**Planning and Community
Development Department**
2880 International Circle
Colorado Springs, Colorado
Phone: 719.520.6300
Fax: 719.520.6695
Website www.elpasoco.com

Project Name : Waterview East Commercial
Schedule No.(s) : 509200002
Legal Description : TR IN SEC 9-15-65 DESC AS FOLS: COM AT THE N4 COR OF SD SEC 9, TH S00-19-23E ALG THE N/S CEN LN OF SD SEC 1613.76 FT TO A PT ON THE SLY ROW LN OF BRADLEY RD, TH S89-30-29W 3.77 FT, TH ALG THE ARC OF A CUR TO THE L HAVING A RAD OF 2759.79 FT, A C/A OF 15-09-41, ARC DIST OF 730.29 FT, WHICH CHORD BEARS S81-55-38W, DIST OF 728.16 FT, TH S74-20-48W 930.15 FT TO THE POB; TH S15-39-12W 394.68 FT, TH ALG THE ARC OF A NON TANG CUR TO THE R, HAVING A RAD OF 75.00 FT, A C/A OF 43-29-55, ARC DIST OF 56.94 FT, WHICH CHORD BEARS S36-01-21W, DIST OF 55.58 FT, TH S57-46-18W 68.47 FT, TH ALG THE ARC OF A CUR TO THE L, HAVING A RAD OF 450.00 FT, A C/A OF 35-44-30, ARC DIST OF 280.72 FT, WHICH CHORD BEARS S39-54-03W, DIST OF 267.19 FT, TH S67-58-24E 40.00 FT, TH S22-01-36W 538.15 FT, TH ALG THE ARC OF A CUR TO THE R, HAVING A RAD OF 260.00 FT, A C/A OF 13-32-35, ARC DIST OF 61.46 FT, WHICH CHORD BEARS S28-47-53W, DIST OF 61.31 FT, TH S00-00-00W 148

Deviation Exhibit 2

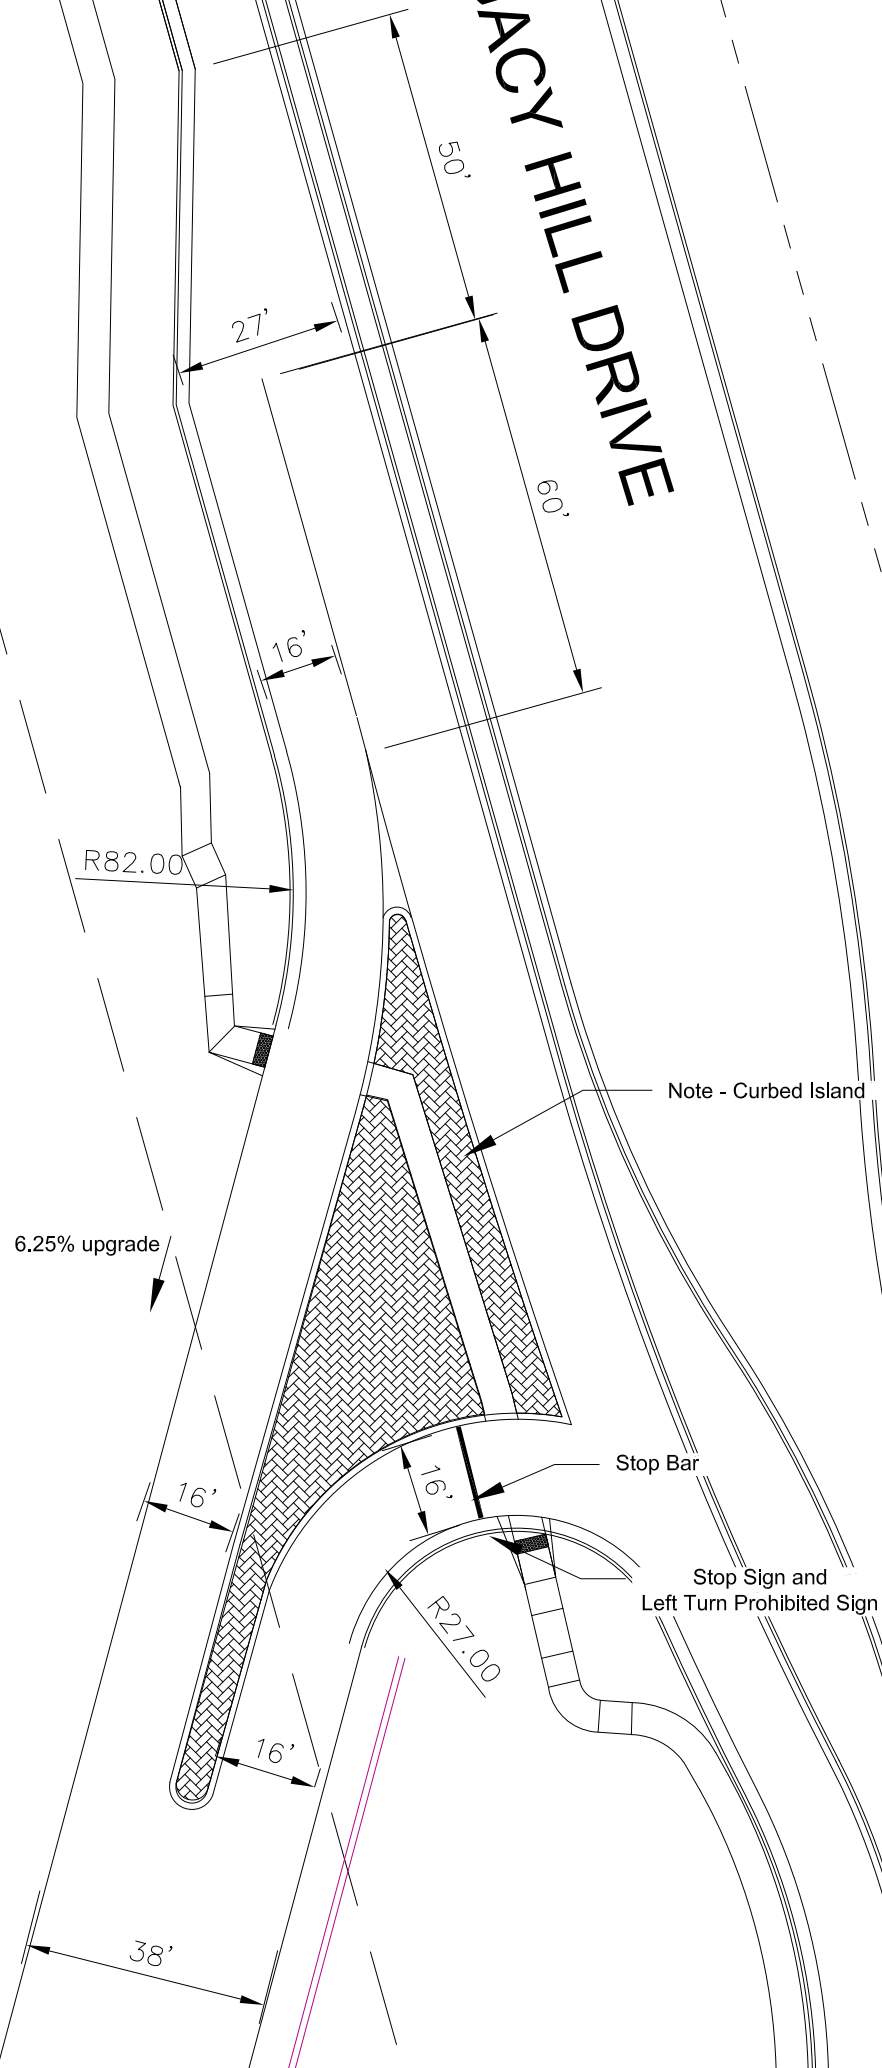
Deviation for RI/RO will be denied, however a deviation for a RI will most likely be acceptable. Adjust the deceleration lane to meet ECM Table 2-24 for approach taper and lane length. The "Storage" design element for Right Turn Lane (see Fig 2-26) is not likely required and should be discussed in the deviation request. Consider starting the taper further north if needed to meet . Also, please provide an Autoturn exhibit showing that design vehicle could make the proposed movement. Also, a Minor plat amendment would need to be done to address the Final Plat note for Filing No. 1 which states that no access will be allowed off of Legacy Drive. Staff recommends the design engineer coordinate and provide a concept sketch of the Right-In lane geometry prior to resubmittal in an effort to expedite review.
